# UNITED STATES PATENT AND TRADEMARK OFFICE

APPLICATION NO.	FILING DATE	FIRST NAMED INVENTOR	ATTORNEY DOCKET NO.	CONFIRMATION NO.
10/516,725	12/01/2004	Johan Christiaan Halberstadt	NL02 0451 US	9943
65913	7590	09/26/2007		
NXP, B.V. NXP INTELLECTUAL PROPERTY DEPARTMENT M/S41-SJ 1109 MCKAY DRIVE SAN JOSE, CA 95131			EXAMINER TRAN, NGUYEN	
			ART UNIT 2838	PAPER NUMBER
			NOTIFICATION DATE 09/26/2007	DELIVERY MODE ELECTRONIC

<b>Office Action Summary</b>	<b>Application No.</b> 10/516,725	<b>Applicant(s)</b> HALBERSTADT ET AL.	
	<b>Examiner</b> Nguyen Tran	<b>Art Unit</b> 2838

## **DETAILED ACTION**

FIG. 4

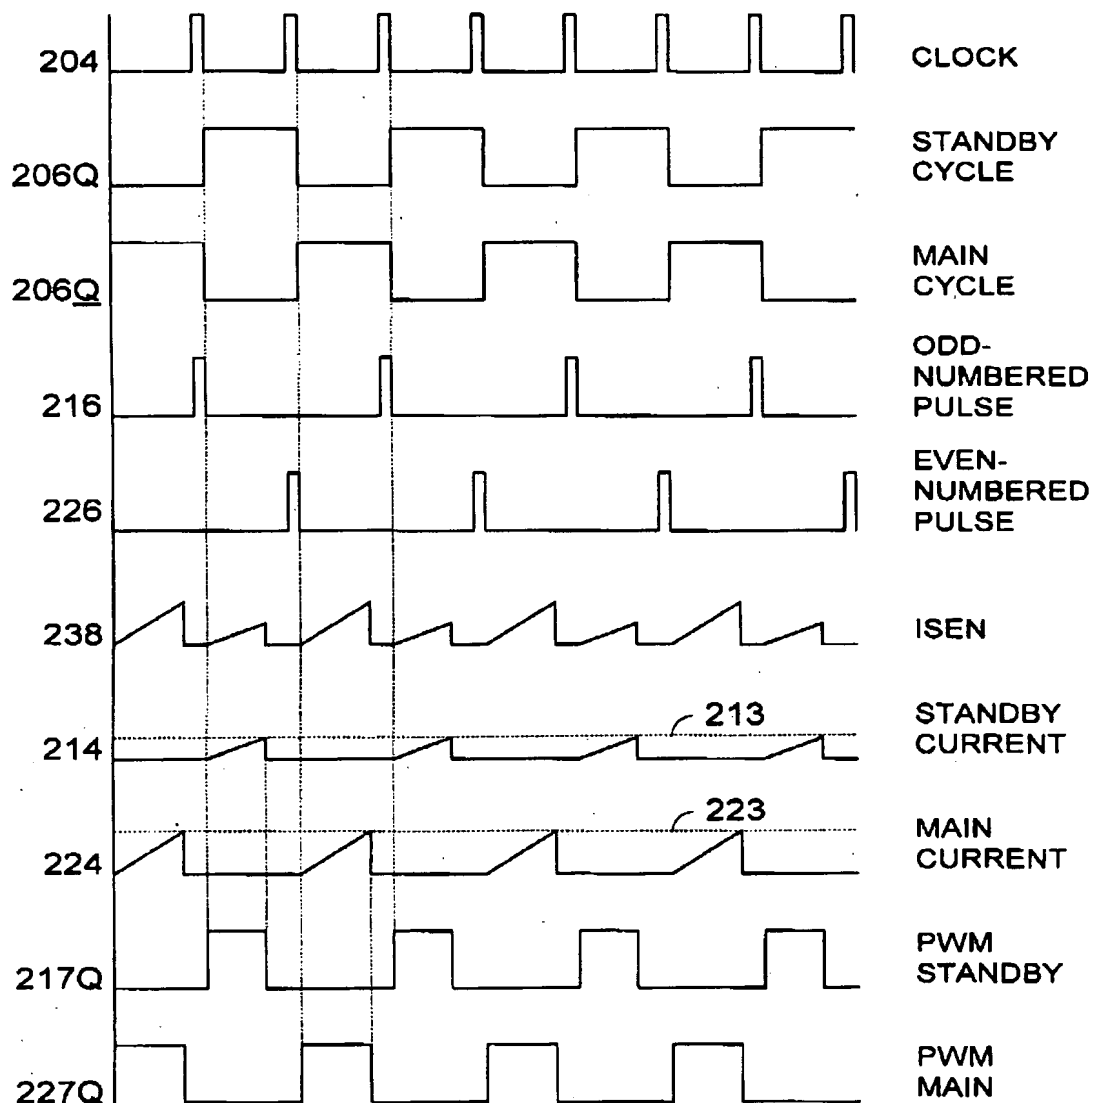
**Claims 1-12** are rejected under 35 U.S.C. 102(b) as being anticipated by Liu (US 5999421).

**Regarding claims 1-12:** for the purpose of examination the Examiner interpreted the claims as shown in figures 4 and 5. Therefor claims 1-12 are rejected under figures 4 and 5 see below.
